City of Plymouth Planning Commission

Special Meeting Agenda

Thursday, July 17, 2025 – 7:00 p.m.
City Hall & Online Zoom Webinar

PUD 25-02: Starkweather Subdivision (behind 550 N. Holbrook), Planned unit development (PUD) amendment to allow lots 17, 18 and 19 to provide signage instead of privacy fences along the rear property lines. The property is zoned PUD, Planned Unit Development.

6 DUMPSTER ELEVATION
A5.0 SCALE: 1/4" = 1'-0"

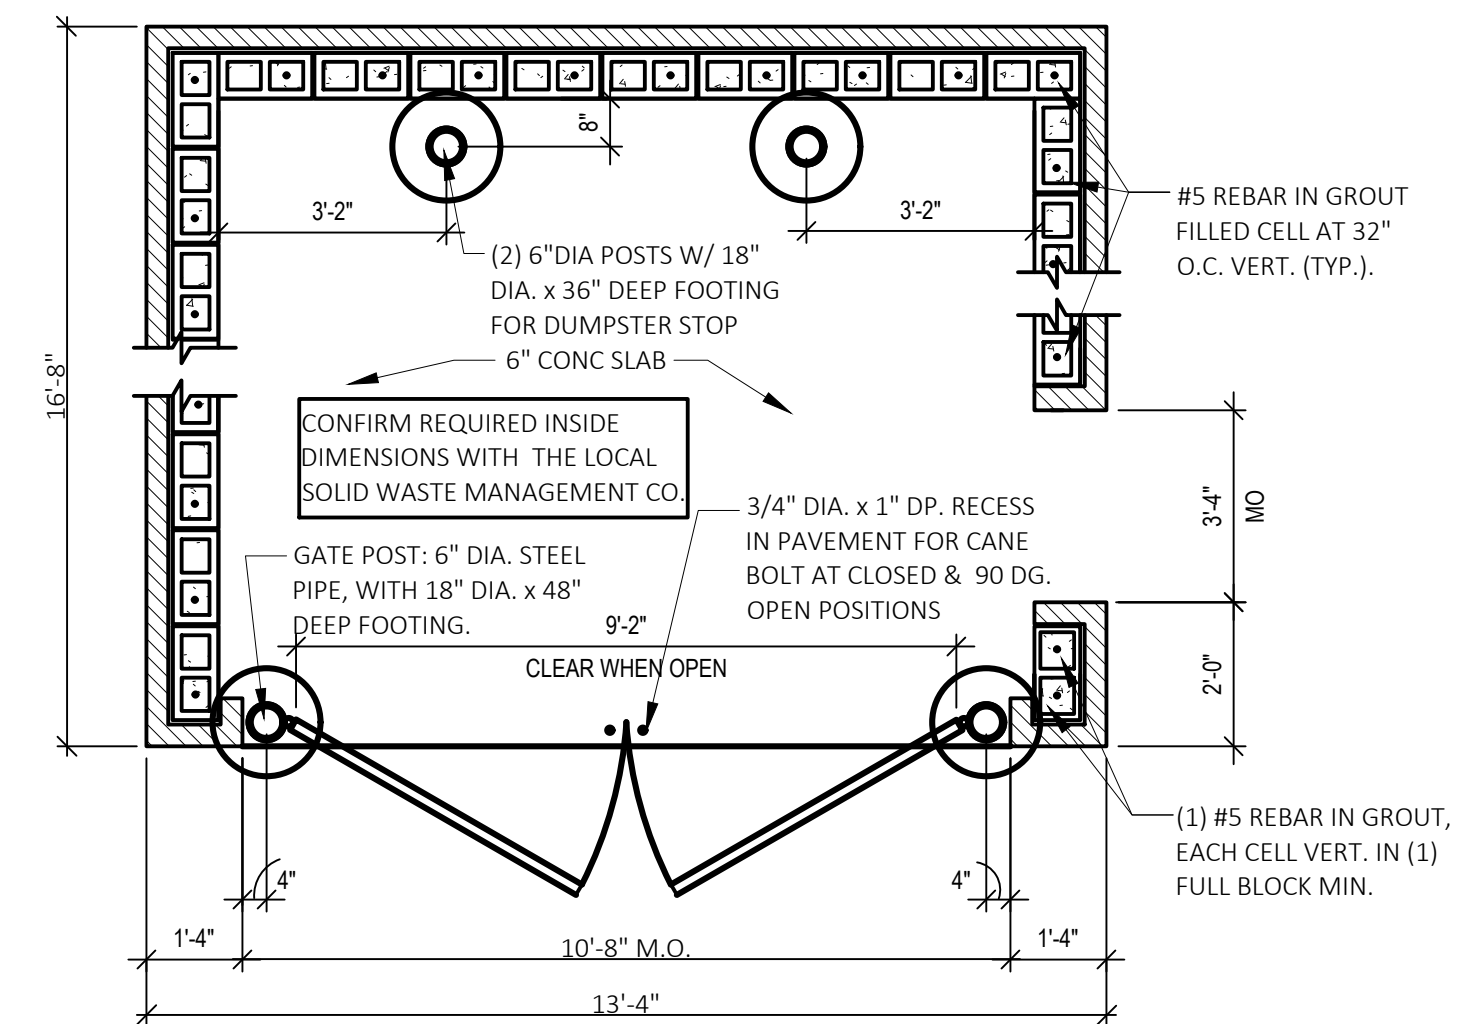
Elevations for the proposed dumpster screen are on Sheet A-5, *Site Details*, which shows the dumpster screen is seven (7') feet – four (4") inches tall. The screen is faced with a three (3') foot tall band of brick matching the building and the remaining four (4') feet – four (4") inches to be Hardie board siding in a vertical board and batten orientation. The enclosure gate is proposed to be four (4") inch ribbed 20 GA metal siding painted “Tate Olive”.

Sheet A-5.0, *Site Details*, provides proposed signage details. In addition to a flagpole, the applicant is proposing one (1) wall sign and two (2) ground signs shown in the figures below.

TITLE:
UTILITY PLAN

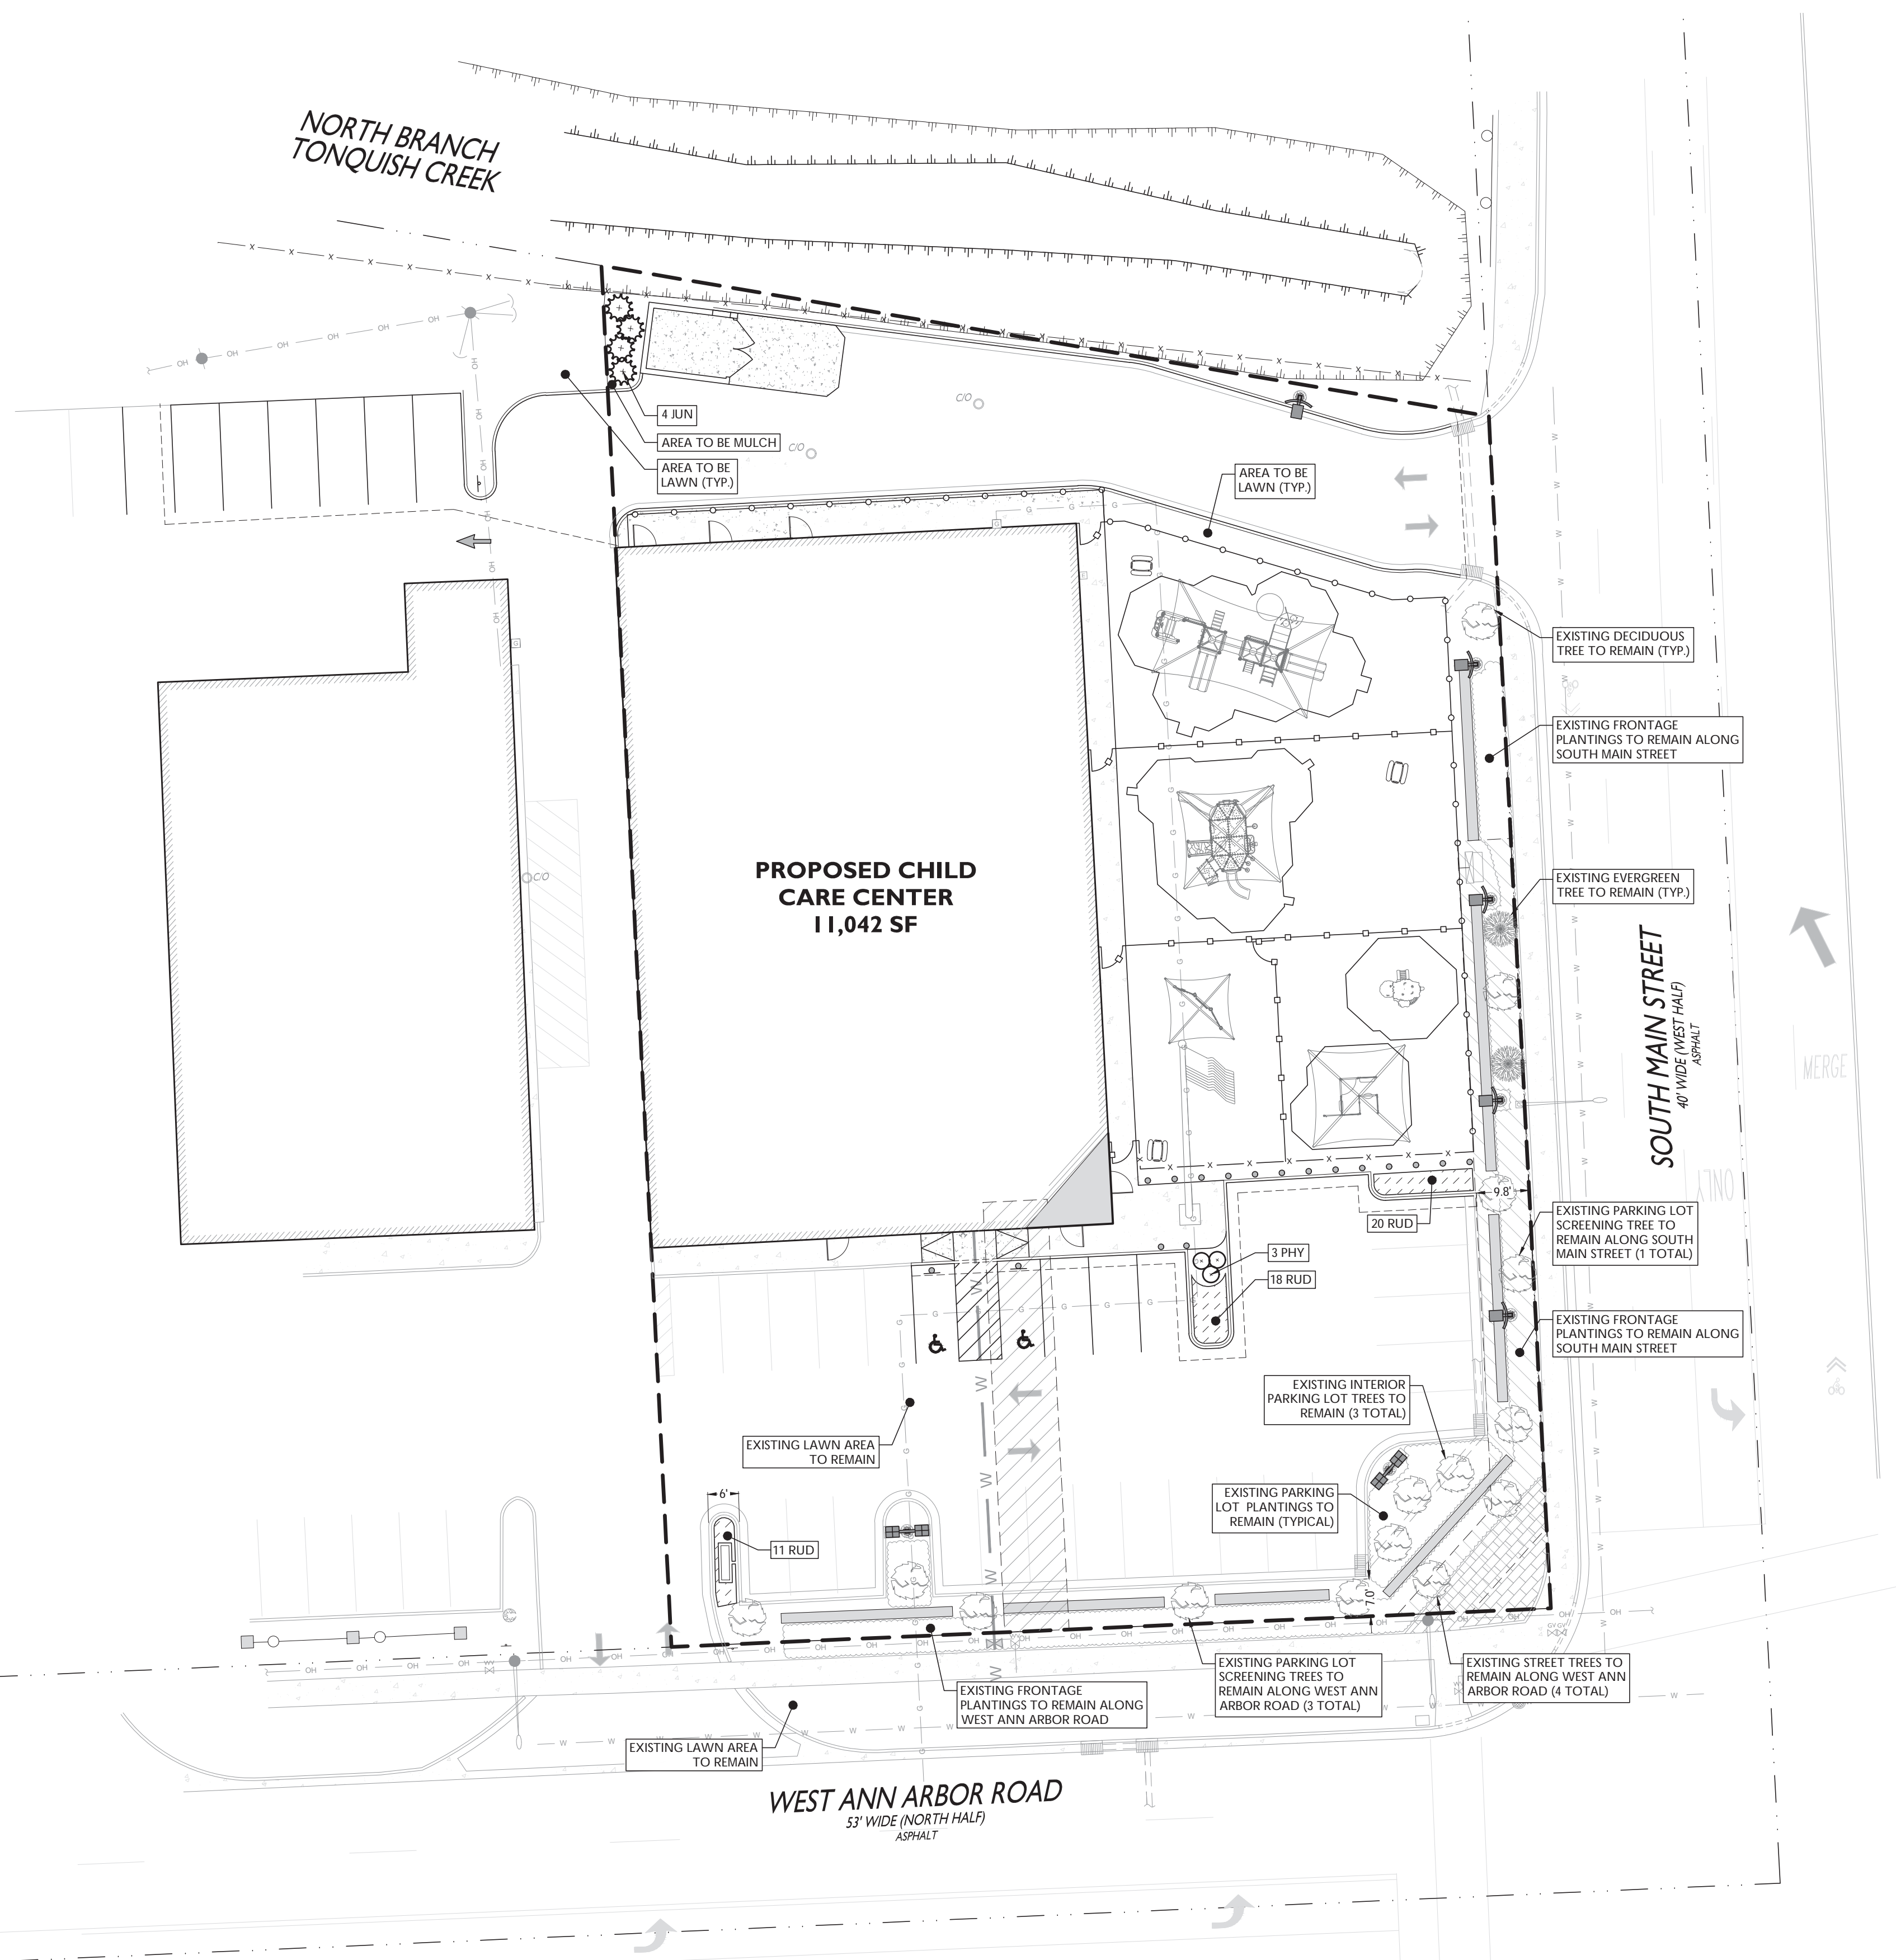
Sheet C-6, *Utility Plan*, depicts a proposed water main connection from the south facing wall to Ann Arbor Road. The Site Plan notes that prior to construction, confirmation of feasibility of connection needs to be made with the water authority. A fire direct connection is proposed in the southeast corner of the site.

Figure 5. Ground Sign #1

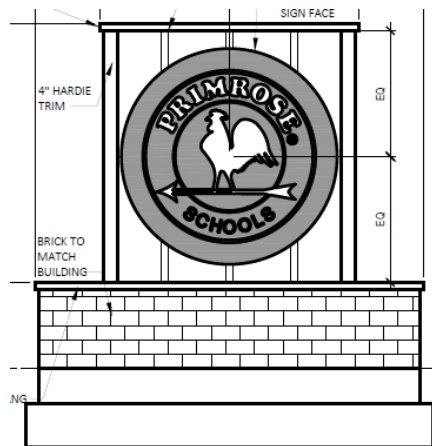
An existing ground sign is shown on the east side of the Ann Arbor Road shared entry drive. The Site Plan indicates that this sign will be modified. It is located approximately 12 feet from the right-of-way line, meeting the location requirements in the ordinance. Sheet A-5.0 notes the final sign placement for **Figure 5.** will be agreed upon between the contractor and franchise owner at a later date. This note should be removed, as it conflicts with the sign placement shown on the Site Plan.

Figure 6. Ground Sign (Mailbox)

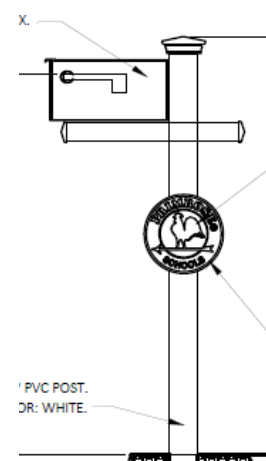
Figure 6. details another ground sign to be fastened to the mailbox. It doesn't appear that the Site Plan shows the location of the proposed mailbox, and this should be added. If the mailbox (and sign) are located on the Main St. frontage, the ordinance would permit a second ground sign on this frontage.
